**DEPARTMENT OF TRANSPORTATION**

**[Docket No. FAA-2015-8463; Directorate Identifier 2014-NM-226-AD; Amendment 39-18612; AD 2016-16-14]**

**Airworthiness Directives; Airbus Airplanes**

**ACTION:** Final rule.

**Figure 1 to Paragraph (1)(4) of this AD – Design A of the Passenger Oxygen Containers**

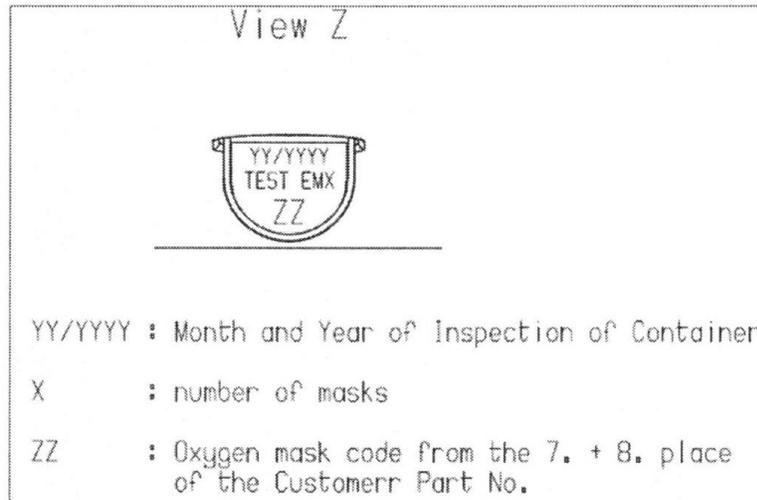
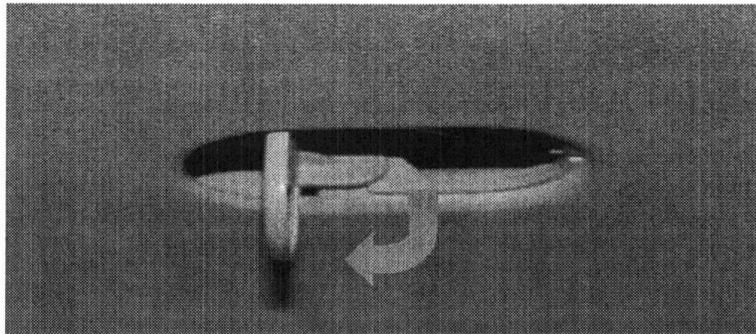
(4) Airplanes on which the design of the passenger oxygen container is not Design A, as defined in figure 1 to paragraph (l)(4) of this AD, are excluded from the requirements of paragraph (i) of this AD for that passenger oxygen container.

Note 2 to paragraph (l)(4) of this AD: For “Design A,” the placard on the passenger oxygen container test button is as described in “Picture A” in figure 1 to paragraph (l)(4) of this AD. The mask configuration (“ZZ” in “Picture A”) is a number, and the test button is as shown in “Picture B.”
